Submitted on Tue, 03/03/2020 - 15:34

Structure Plan - Rossmore
Western Sydney Aerotropolis

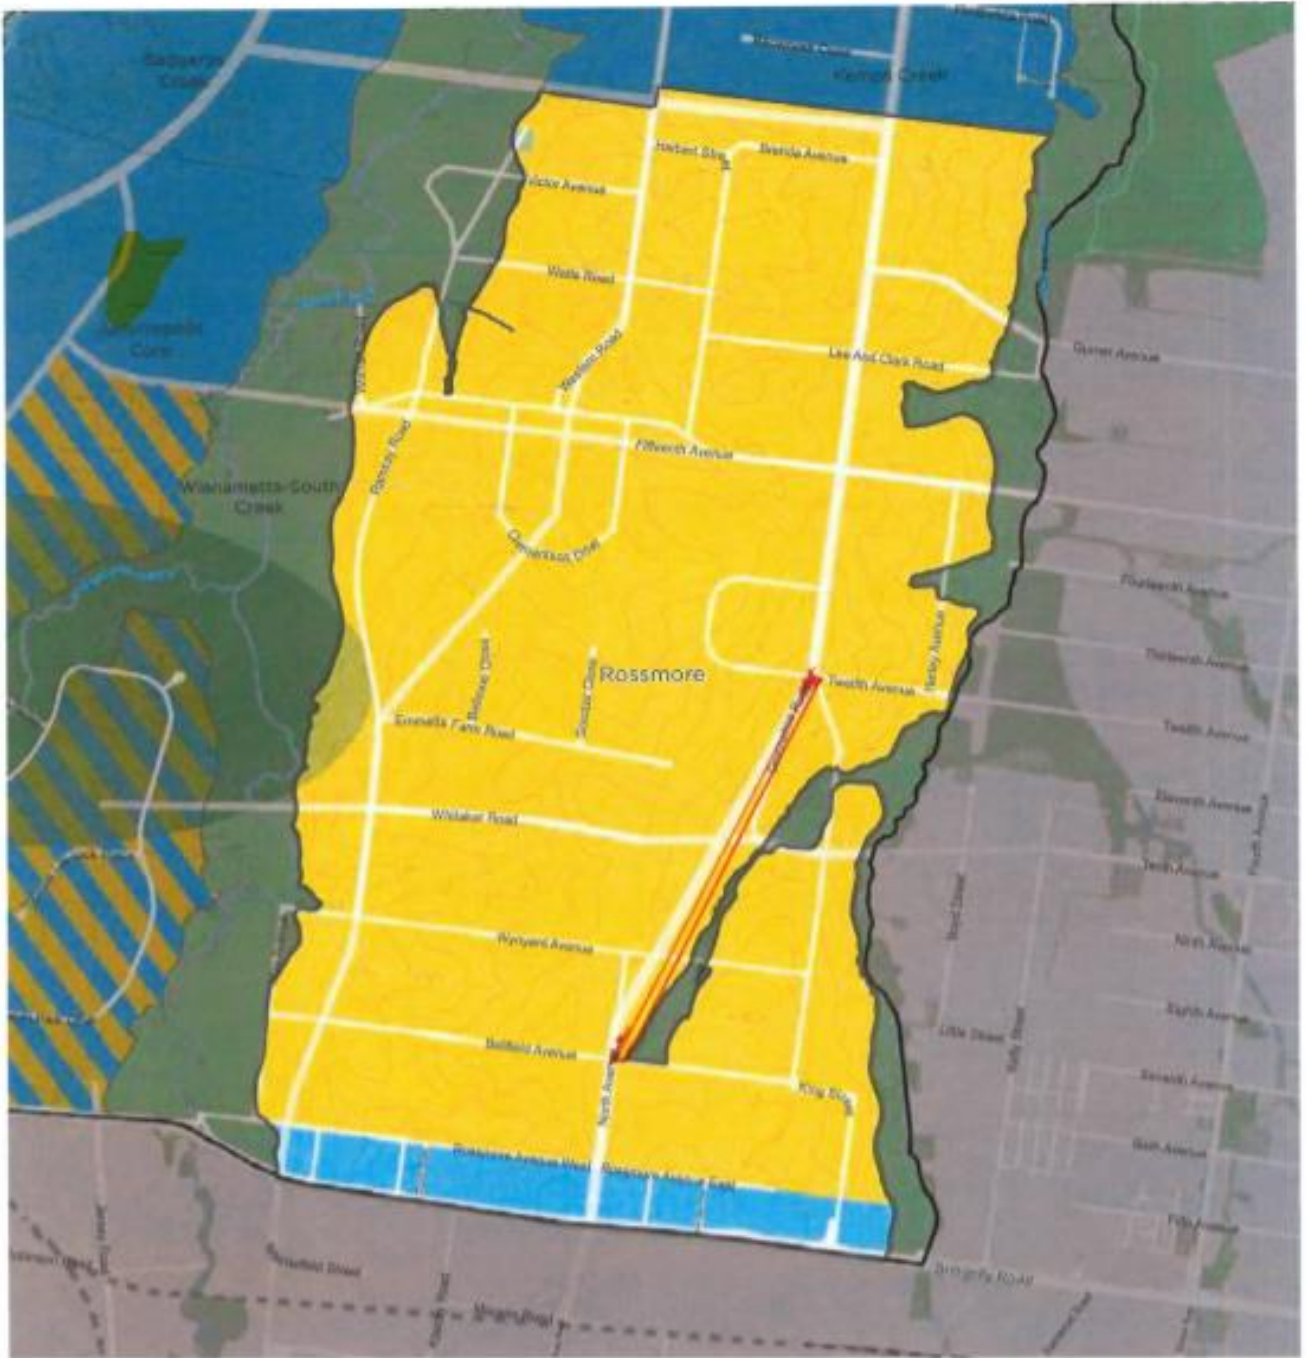
i hereby plead with you to reconsider the diagonal road (Devonshire Road) which intersects large parcels of houses, multigenerational business and valuable urban land.

why does this large diagonal Road need to intersect wynyard avenue and meet the middle of North Avenue. i cant for the life of me see the rational behind this.

I have attached a PDF copy of the Rossmore precinct which shows a potentially new road which is far more closer to the Green Areas or on urban land hence cutting the wastage.

I implore you to reconsider your position of intersecting Devonshire road through the Middle of North Avenue as this is will leave land unusable and worthless. surely there must be a better way.
